Road Safety Audit Stage 2-Designer's Response A7 Guthrie Drive Pedestrian Improvements

RSA/16/005/RSA2 /001

Project Name:	A7 Guthrie Drive Pedestrian Improvements
Project Number:	RSA/16/005/RSA2
Report Title: Road Safety Audit Stage 2-Designer's Response	
Report Number:	001

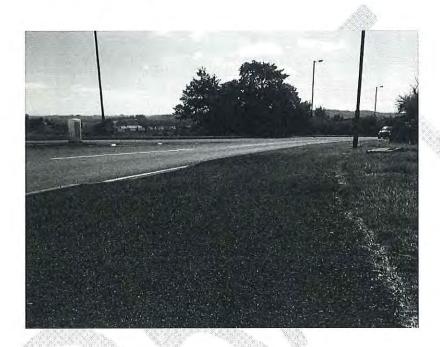
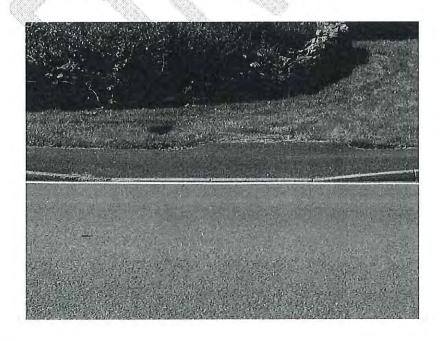
Summary: The surface of the western footway at crossing point 2 is uneven and presents a trip hazard for users. To effectively remove this hazard and ensure that the footway has a consistent gradient the existing manhole could be lowered to avoid issues for the mobility impaired.

Reduce the level of the existing manhole so that a consistent surface level is provided

Agreed – Upon further inspection the footpath surrounding the manhole chamber can be reprofiled to remove the trip hazard

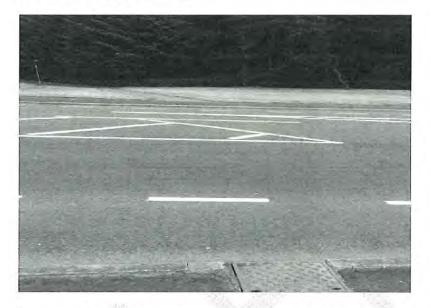
Summary: The new refuge island will be installed on a steep gradient and lies within a section of the trunk road where vehicle speeds would be expected to be high. To make drivers aware of the presence of the island particularly in poor light conditions it would be beneficial to have a beacon installed to aid visibility of pedestrians waiting at the refuge island.

Install a refuge beacon at the new refuge island

Agreed – The installation of 2 new lighting beacons have been incorporated into the designs for pedestrian refuges.

Appendix B

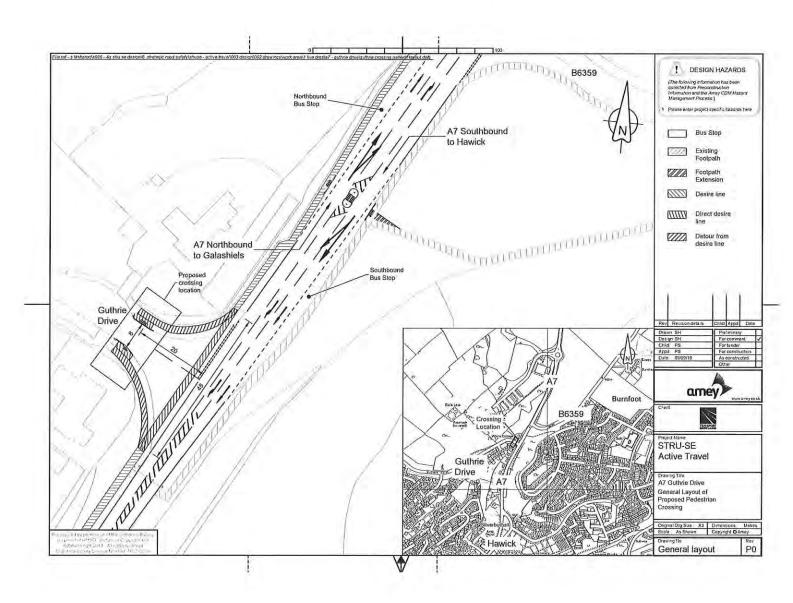
Summary: The proposed crossing point 4 is not on the desire line for users of the A7. This is likely to result in pedestrians crossing at the bell mouth of Guthrie Drive bringing them into conflict with vehicles turning at speed into the junction.

Create a crossing point on the trunk road desire line incorporating a refuge island

Disagree -

A crossing located at the bell mouth of the junction, assuming a straight line between footpaths, would require pedestrians to cross approximately 35m of carriageway (kerb to kerb). This would result in pedestrians coming into close proximity to traffic travelling on the mainline with a speed limit of 60mph, and entering Guthrie Drive at speed due to the generous bend and carriageway width.

At the proposed location, a crossing will meet the needs of users travelling to/from the Guthrie Drive area. Whilst this location may not be on the exact desire line for pedestrians travelling alongside the A7 northbound carriageway, the location has been selected based on criteria outlined in Transport Scotland design standards and DMRB (Volume 6, Section 2, Part 6 TD42/95 paragraph 5.15) which states "Defined at-grade pedestrian crossing points on the minor road should be a minimum of 15m back from the "Give Way" line, and should be sited so as to reduce to a minimum the width to be crossed by pedestrians provided they are not involved in excessive detours from their desired paths." This would result in a deviation of approximately 20m from the auditor's desire line, which is not considered to be excessive.

A drawing of the proposed crossing and images of the existing crossing is contained within Appendix B.
